Serial No.: 10/820,438

Response dated: March 10, 2006

In reply to the Office action mailed: November 10, 2005

## Amendments to the Drawings

FIG. 3

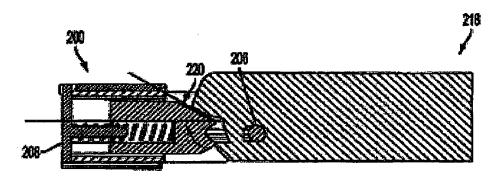
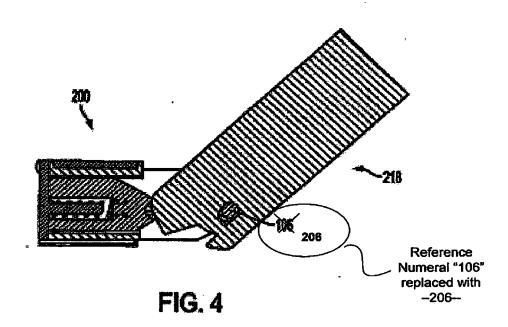
FIG. 4 has been amended to replace the reference numeral "106" with --206--.

FIGS 2, 4, and 10 were objected to for not including reference signs mentioned in the

specification. These figures have been amended to add the missing reference numerals, or where

appropriate to replace an incorrect reference numeral with the proper reference numeral. The

FIG. 10

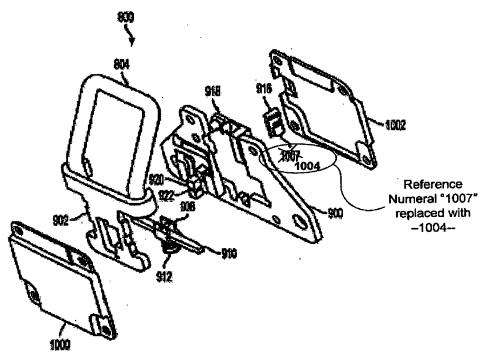
FIG. 10 has been amended to replace the reference numeral "1007" with --1004--.

FIG. 19

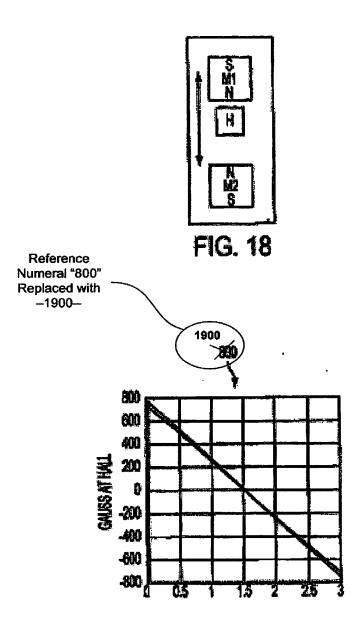
FIG. 19 has been amended to replace the reference numeral "800" with --1900--.

FIG. 19 has been amended herein to replace the reference numeral "800" with the

reference numeral "1900". The specification has been amended at paragraph [0057] to read
